# United States Patent and Trademark Office

APPLICATION NO.	FILING DATE	FIRST NAMED INVENTOR	ATTORNEY DOCKET NO.	CONFIRMATION NO.
09/847,264	05/02/2001	Lyn Rosenboom	457009-2 6915	
7590 05/01/2006			EXAMINER	
Michael C. Gilchrist			BATSON, VICTOR D	
Dorsey & Whitney LLP Suite 3900			ART UNIT	PAPER NUMBER
801 Grand Avenue			3671	
Des Moines, IA 50309			DATE MAILED: 05/01/2006

#### **DETAILED ACTION**

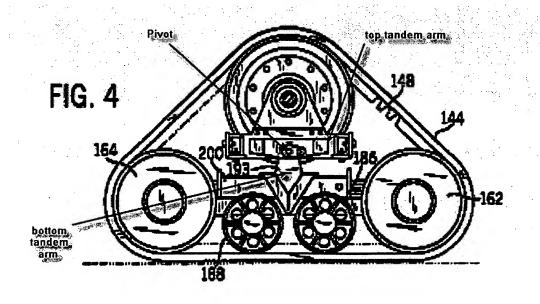
Claims 1 &12 are rejected under 35 U.S.C. 102(e) as being anticipated by Lykken et al. (6,318,484).

Lykken et al. discloses a track assembly having all of applicant's claimed structure including a top tandem arm 102, a bottom tandem arm 193, an adjustable frame (including members 194 & 196 shown in figure 6) for adjustably spacing front and rear idler wheels 164 & 162, and a belt 144 as shown in figures 3 & 4.

Applicant's arguments filed 2/8/06 have been fully considered but they are not persuasive. Applicant argues that neither Lykken nor Gignac correspond to the claims as amended. The examiner disagrees and notes that applicant's arguments are more limiting than the claims themselves. For example, in claim 1 applicant does not include

structure that would preclude members 194 & 196 from being considered the frame. Applicant argues that the structure asserted as the top tandem arm ("idler wheel carriage 102") is not pivotal because it is rigidly attached to the frame by mountings. Although the carriage 102 is rigidly attached to mountings 20, the examiner notes that carriage 102 is pivotally attached to the frame (considered the combination of members 194 & 196) by it's pivotal connection to member 193 (see figures above). Applicant further argues that Lykken does not have a first wheel attached to its top portion. The examiner notes that the limitation "attached" is considered similar to "connected to one another", which includes being joined together, but is broader than that, in that two things can be "connected" to each other by way of their common connection to something else. Kreis AG v. American Hospital Supply Corp. (DC NIII) 192 USPQ 585.

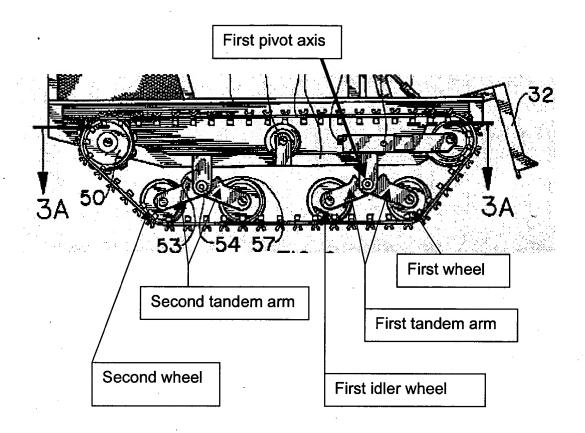
Claims 6-8 are rejected under 35 U.S.C. 102(e) as being anticipated by Gignac (6,125,956).

Gignac discloses a track assembly having all of applicant's claimed structure including a wheel frame, a first tandem arm 46 pivotally connected to the wheel frame, a first wheel operably connected to the wheel frame by the first tandem arm, a second wheel 60, a continuous ground-engaging belt, a first idler wheel structure as identified in the modified figure below. Gignac further discloses a hitch member 105.

Applicant further argues that Gignac does not show or suggest the first idler wheel structure and the first wheel rock about the first pivot axis in a reciprocating manner to maintain a desired distribution of weight between said first wheel and said first idler wheel structure. It is the examiner's position that the first wheel and the first idler wheel rock about a first pivot axis (see figure above), and that the phrase "to maintain a desired distribution of weight between said first wheel and said first idler wheel structure" is considered an intended use recitation.
